Executive Director's Recommendation

PROJECT**Dwight D. Eisenhower Memorial**

Final approval of site and building
plans

Approve with comments

Figure 20: Diagram showing relationship of tapestry and freestanding columns to Maryland Avenue right-of-way

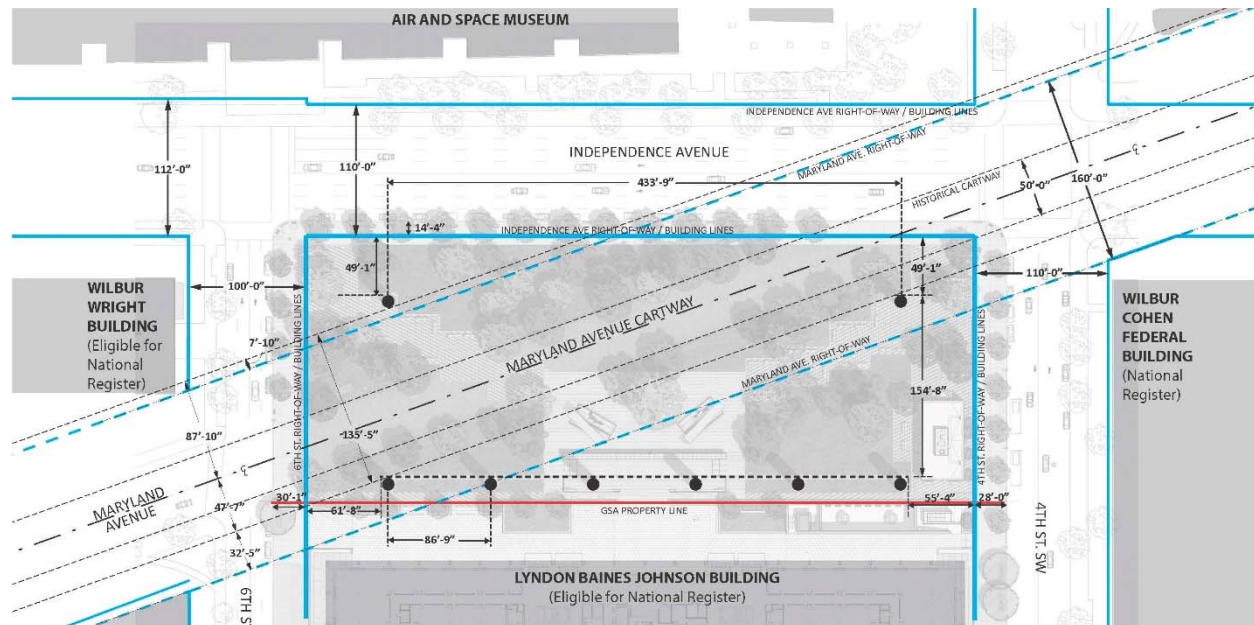
In October 2014, the Commission found that the preliminary plans satisfied this design principle. With the final design, the memorial continues to meet this design principle. As staff noted in October 2014, the use of two freestanding columns rather than the east and west tapestries as was proposed in April 2014, result in a substantial improvement to the Maryland Avenue view corridor and relationship of the memorial to its surroundings. As discussed in previous staff reports (April 2014 and October 2014), during site selection, the Maryland Avenue cartway was identified as a development restriction zone, and that the remainder of the 160-foot right-of-way and the viewshed needed to be treated in a sensitive manner with regard to placement of memorial elements.

The placement of the west freestanding column on the edge of the right-of-way preserves, to a great extent, the openness of Maryland Avenue and the horizontal orientation of the viewshed. The final design retains elements of the memorial within the 160-foot right-of-way, specifically the western end of the tapestry and eastern freestanding column. As was the case with the preliminary plans, the view towards the Capitol is approximately 135 feet wide or approximately 84% of the width of the right-of-way (Figure 20). Staff's position is that the placement of elements within the viewshed is proposed in a way that preserves the prevailing civic – *more horizontal* – character that is typical of the city's broader, more significant avenues which allows public buildings and commemorative works to be the dominant elements within these important view corridors. The

final design is a successful compromise between establishing a fitting scale for a Presidential memorial and respecting the site's historic context and unique constraints.

Figure 22: Pedestrian circulation diagrams (October 2014 – top; Final Design – below)

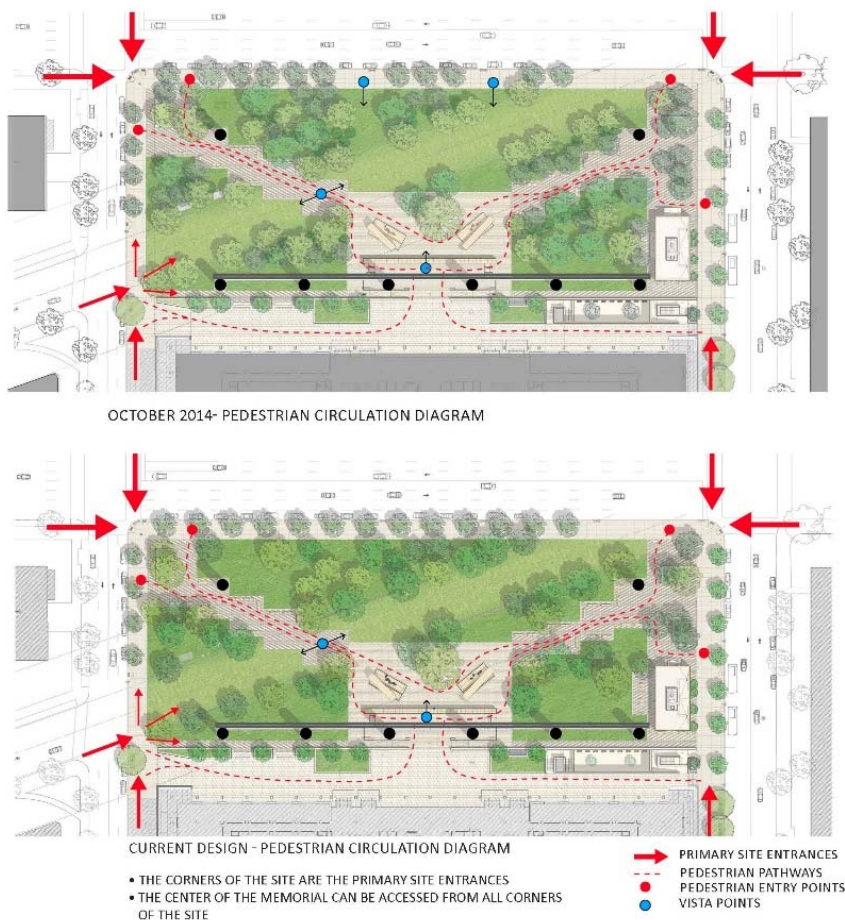
In April 2014, the Commission commented that the pedestrian circulation was too narrowly focused on providing access from the site corners to the memorial core and needs to take into consideration likely circulation patterns along Maryland Avenue and mid-block from Independence Avenue. In response, the landscape plan has been revised to eliminate the break in the street trees and canopy trees along Independence Avenue (Figure 22). This modification reduces the vistas towards the memorial core at this location and will deter pedestrians from walking across the lawn towards the memorial core. In addition, based on current pedestrian circulation in the area, the design team believes that the primary pedestrian circulation into the site will occur at the two corners: Independence Avenue and 4th Street and Independence Avenue and 6th Street. A secondary pedestrian circulation pattern onto the site is from Maryland Avenue and 6th Street. The applicant's position is that the final design has incorporated generous paved areas at the entry plazas and the Information Center to accommodate various circulation patterns. Staff agrees that by eliminating the break in the canopy trees, it is less likely that pedestrians will cross lawn to gain access to the memorial core.

The applicant has stated that the entire groundplane in the memorial site is accessible and that the turf and soil have been designed for high traffic. The groomed lawn along Maryland Avenue is intended to offer an opportunity for pedestrians to experience views to and from the U.S. Capitol. The design team considered a number of options for a paved walkway along Maryland Avenue, but ultimately determined the addition of a paved pathway interrupts the unity of the site organization and circulation pattern. The design team also believes a pathway would compromise the unique feature of the memorial landscape design with an open greensward along Maryland Avenue.

Staff finds that with the revised landscape design and elimination of the gaps in the canopy trees along Independence, it will be less likely for pedestrian to cross the site mid-block from Independence Avenue. In addition, while there is a secondary circulation pattern from Maryland and 6th Street which will encourage visitors to walk along the Maryland Avenue, the turf has been selected to withstand this kind of use.

Figure 24: Perimeter Security for LBJ Promenade (July 2015)

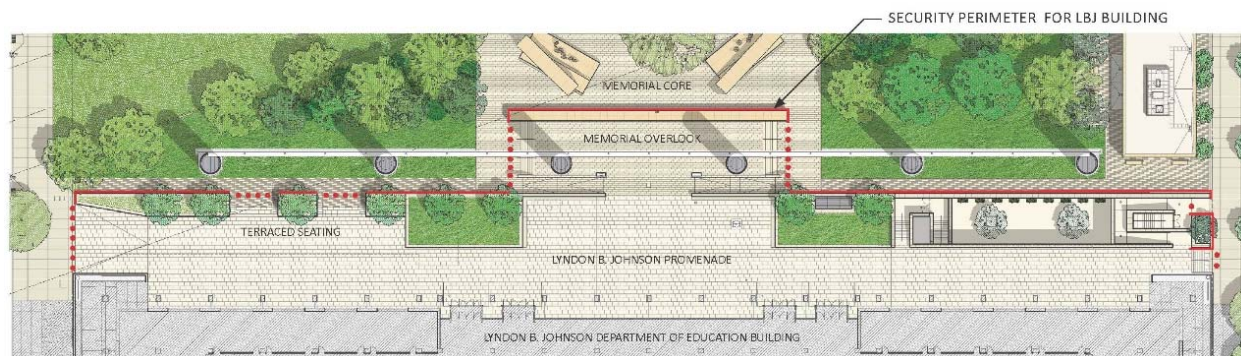
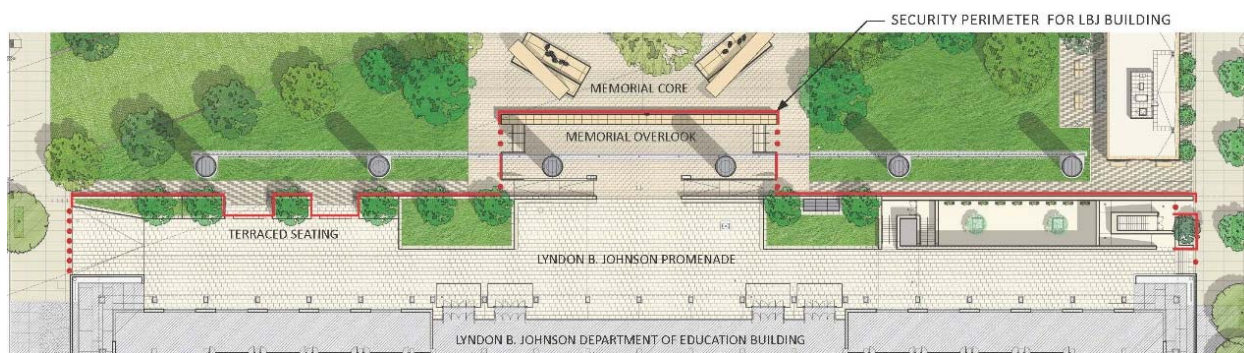
In April 2014, the Commission commented that the proposed bollards along LBJ Promenade should be eliminated, particularly those located at the base of the Memorial overlook, or modified in design and spacing to maintain the openness of the Promenade and avoid unnecessary obstructions to pedestrian circulation (Figure 23). In response, the design team developed a solution that involved a structural wall clad in stone that would eliminate the need for bollards and presented that to the Commission in November 2014. However, since that time, CFA commented that the structural walls break up the stair and so the design was modified in response. The stairs were shortened in front of the tapestry column and the overlook platform was extended. With this modification, the number of bollards was reduced to two in these locations (Figure 24).

Other modifications to the perimeter security design included the elimination of bollards at the terraced seating area as the west end of the LBJ Promenade. In place of the bollards, a structural wall was added at the top of the seating areas. The wall forms a back to the upper tier seating and allows access to the stairs on either side of the seating area. The wall will be clad in precast

Staff finds that the Commission's comments related to perimeter security have been addressed by the applicant through modifications to the design and elimination of the bollards. The bollards that are proposed have been kept to a minimum and should not obstruct pedestrian circulation.

Figure 25: Alignment of trees on Maryland Avenue

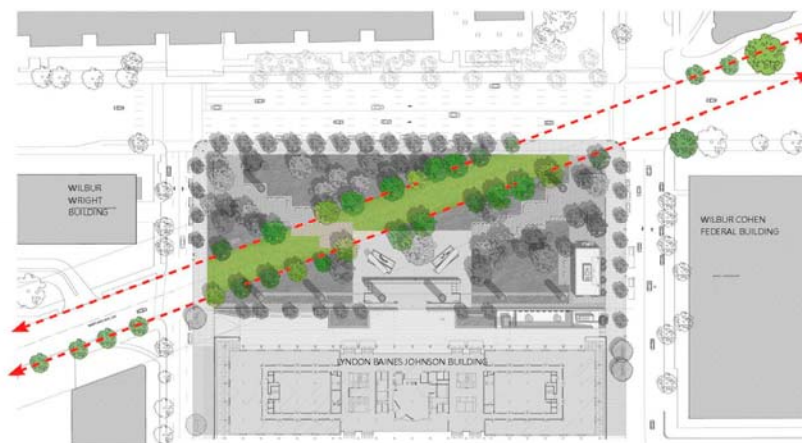
At the time of preliminary approval in October 2014, the Commission requested that the design team continue to explore ways to enhance the openness of the Maryland Avenue right-of-way/viewshed. The final design includes an allée of trees along Maryland Avenue and since the Commission's preliminary approval the applicant has refined the tree species and placement of trees along the allée to reinforce the viewshed toward the U.S. Capitol (Figures 25 and 26). In addition, the historic cartway of Maryland Avenue has been enhanced with a wider granite curb to separate the groomed turf from the taller grasses on either side of Maryland Avenue. With the modifications to the landscape design and the allée of trees along Maryland Avenue, the openness of Maryland Avenue as the primary view corridor has been strengthened. The increase in the size of the granite curb marking the historic cartway of Maryland Avenue also contributes to enhancing the significance of Maryland Avenue.
